**Design Review & Historic Preservation Board  
Agenda  
September 9, 2021**

**Design Review and Historic Preservation Board**  
**Minutes**  
**August 26, 2021**

MAIN HOUSE ELEVATIONS 1/4" = 1'

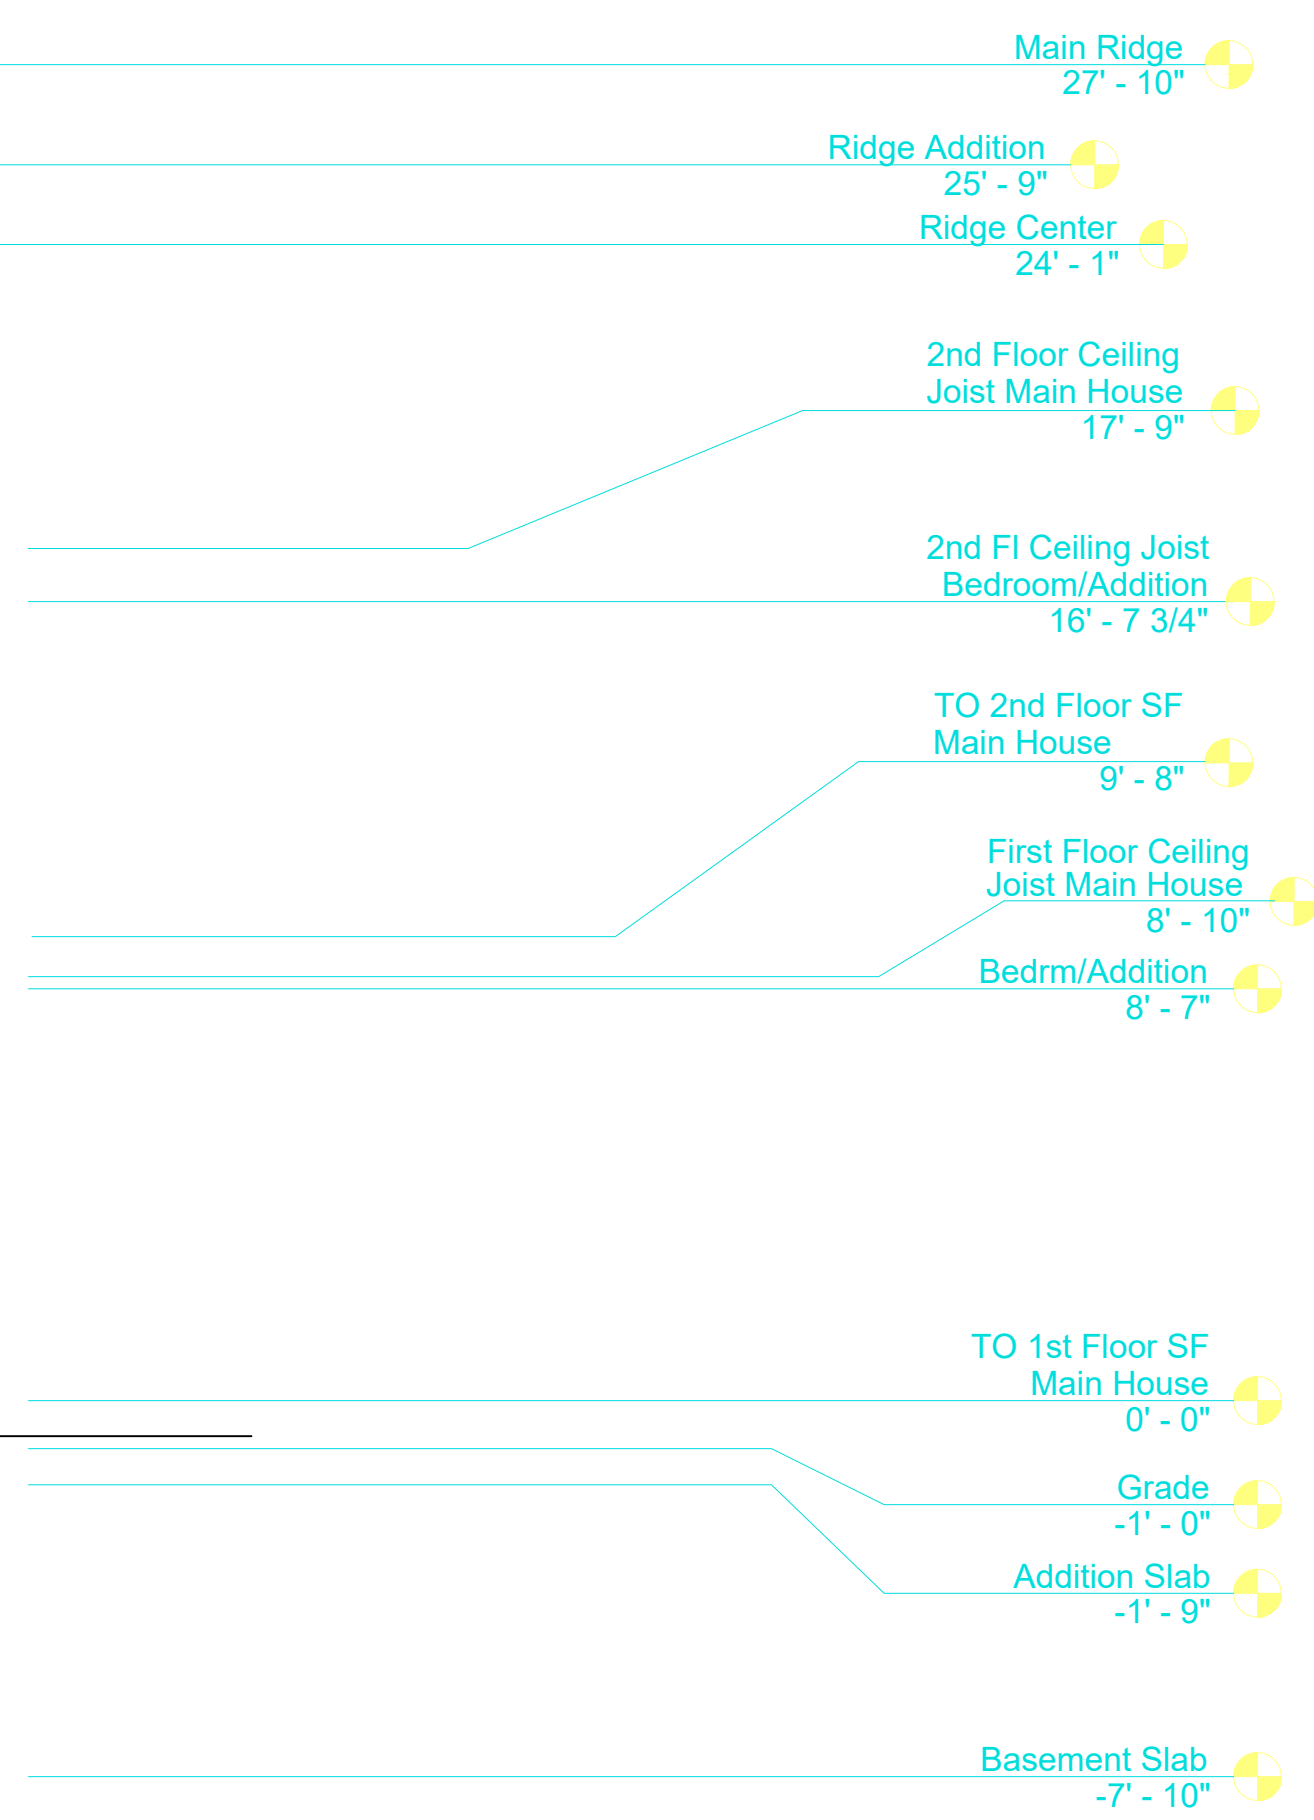
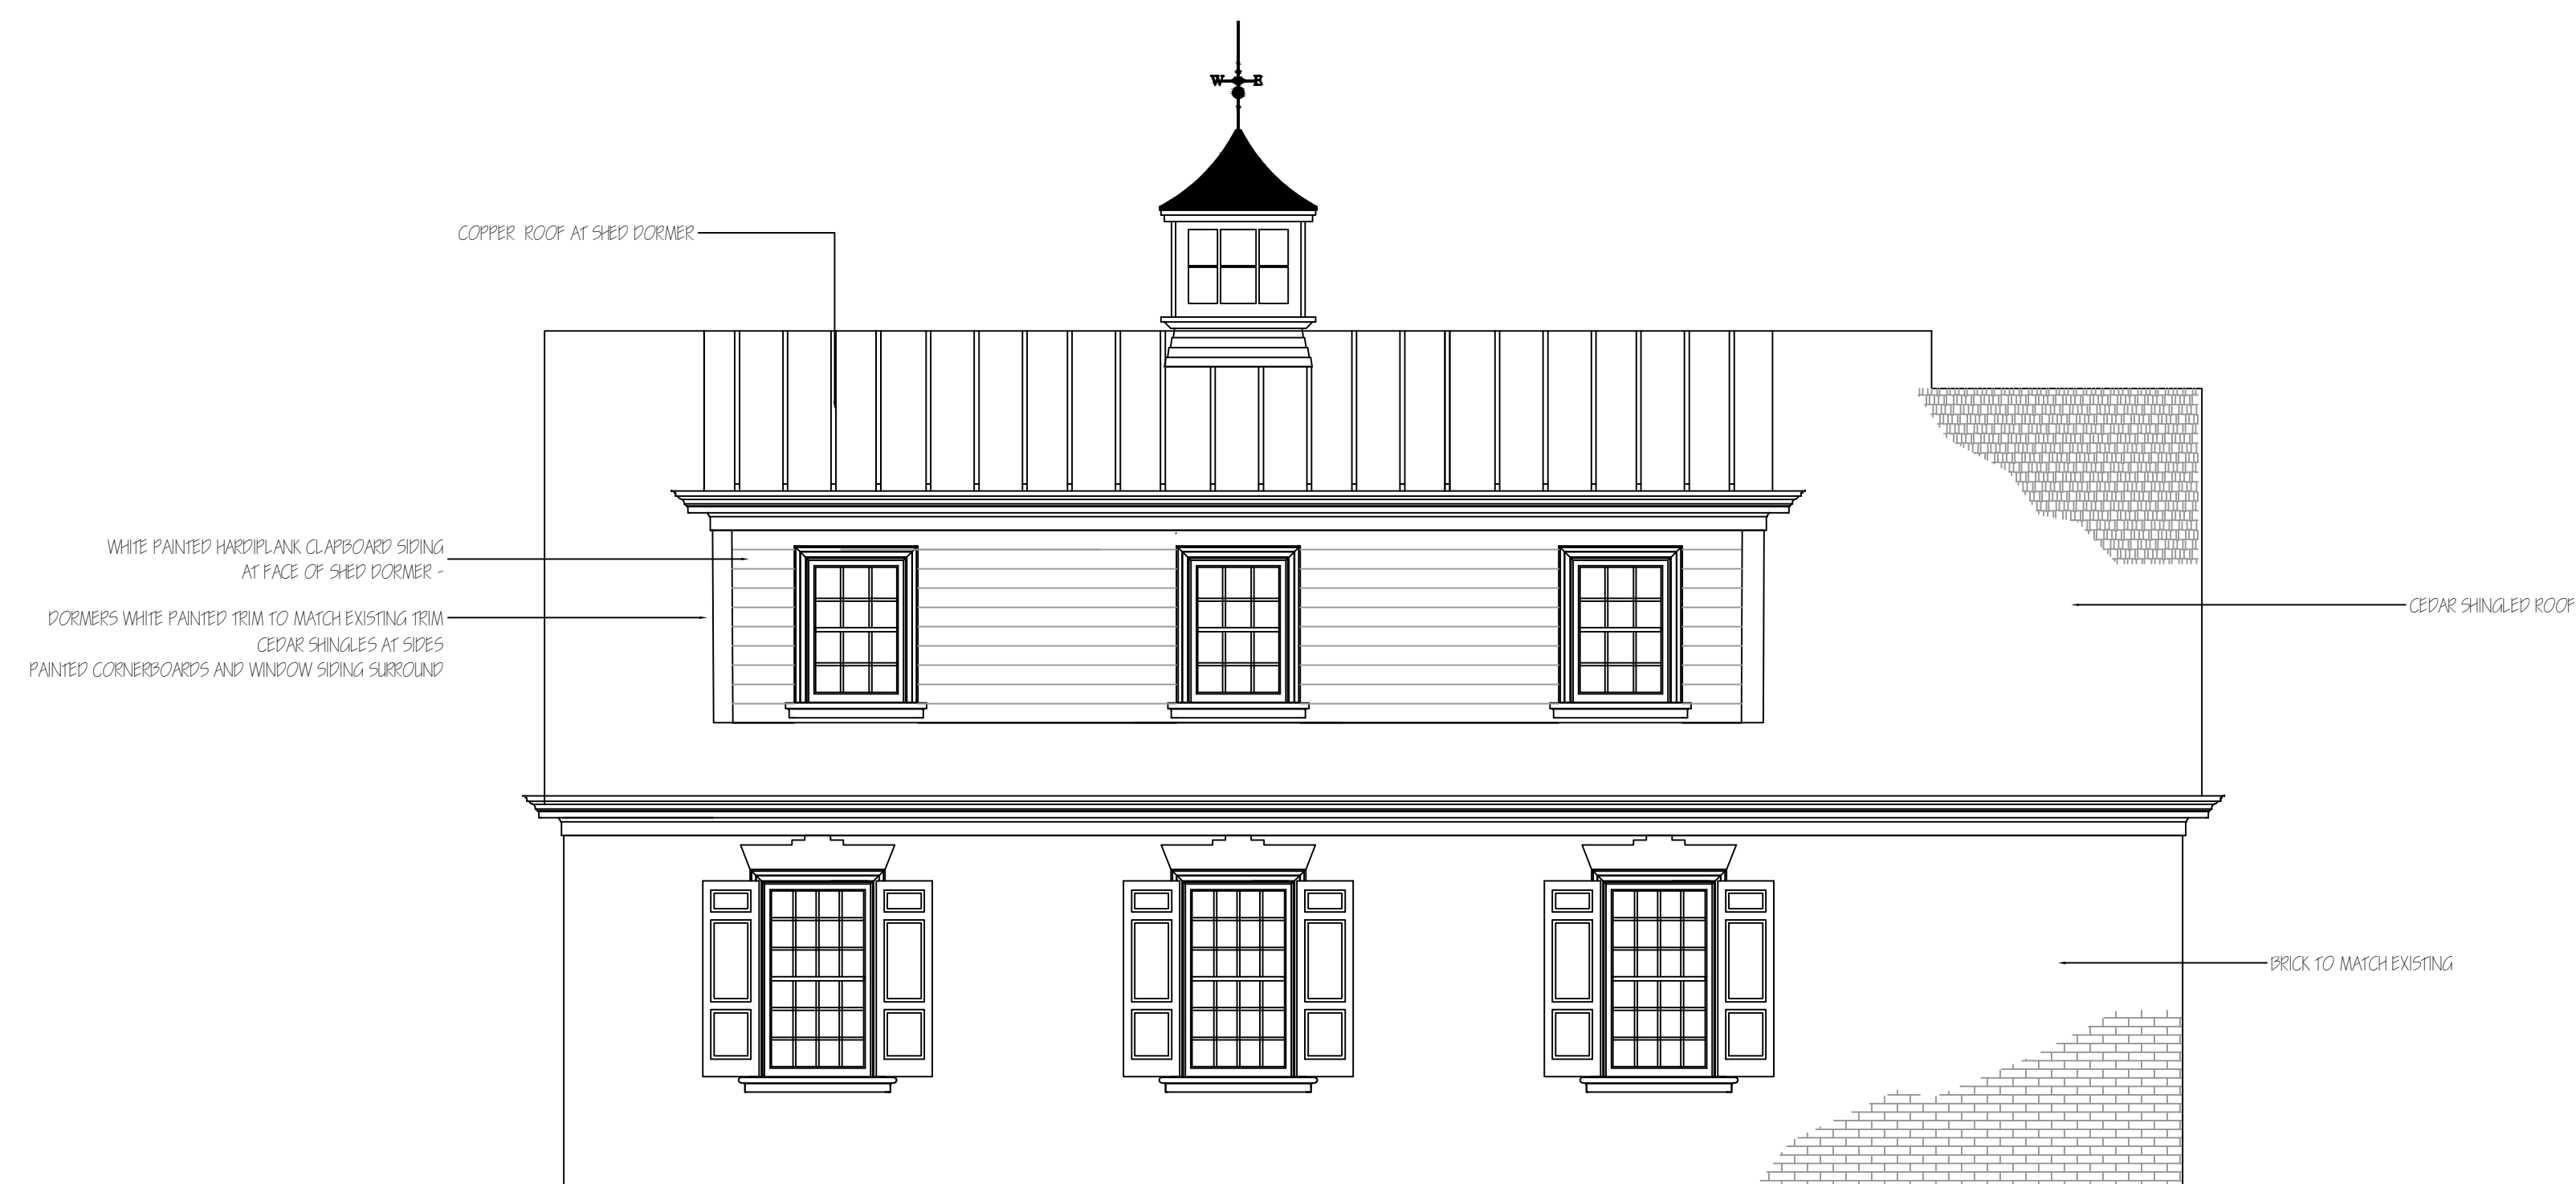
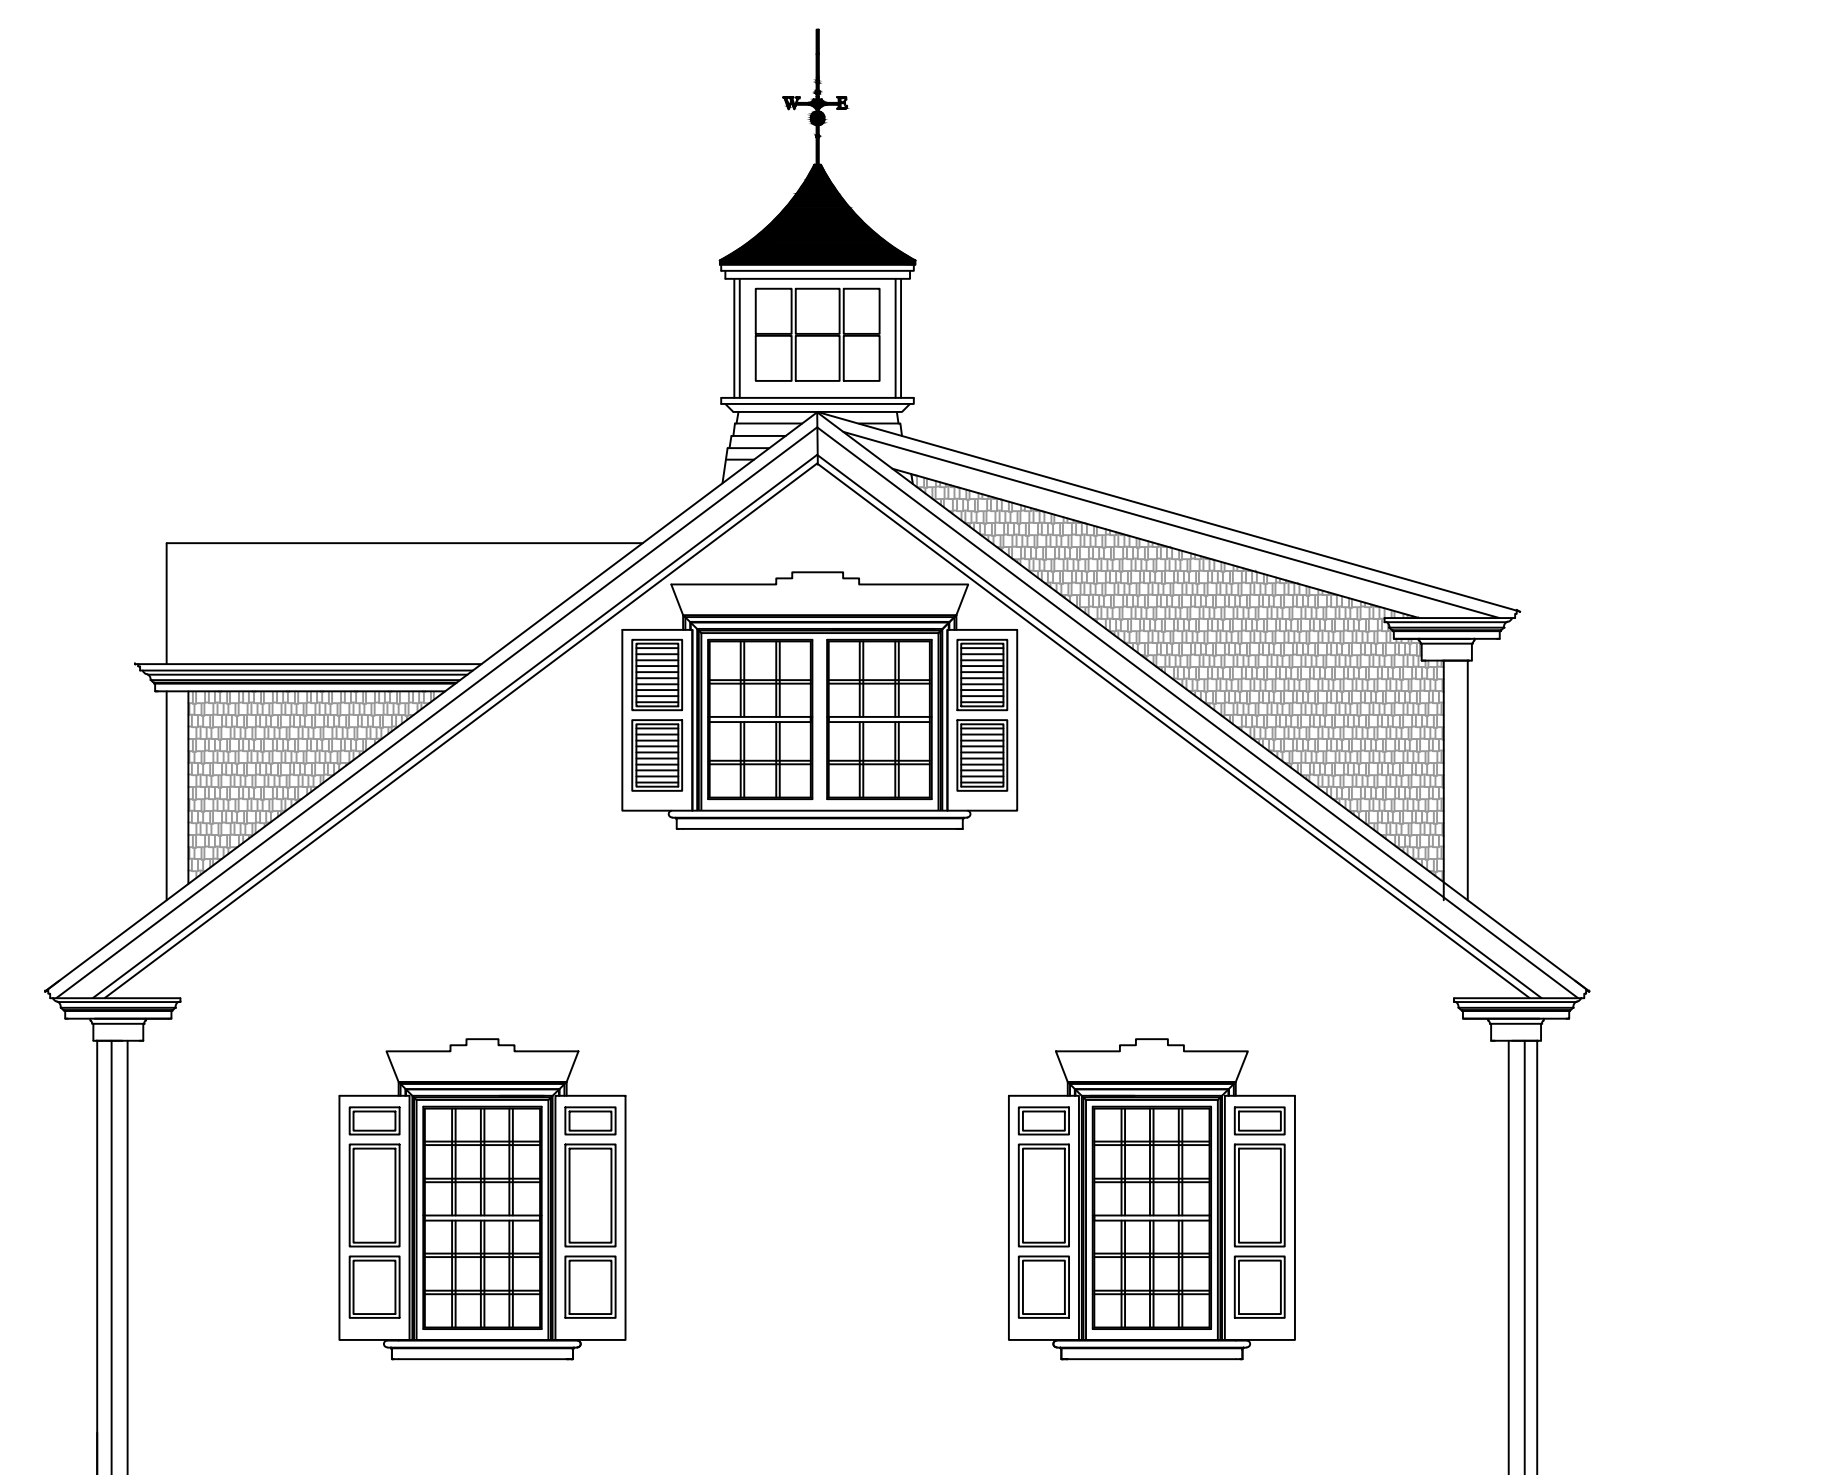
The Board discussed and agreed that detailed information is missing on the drawings and needs to be provided. Examples of missing information included but not limited to:

1. Downspout locations
2. Shutter style
3. Type of windows and doors being installed – windows should be the same
4. Deck/porch materials
5. Colors to be used (i.e. color name and color code)
6. Column details

The applicant needs to outline on the elevations exactly what she proposes doing on all elements of the home exterior. A full working drawing needs to be submitted.
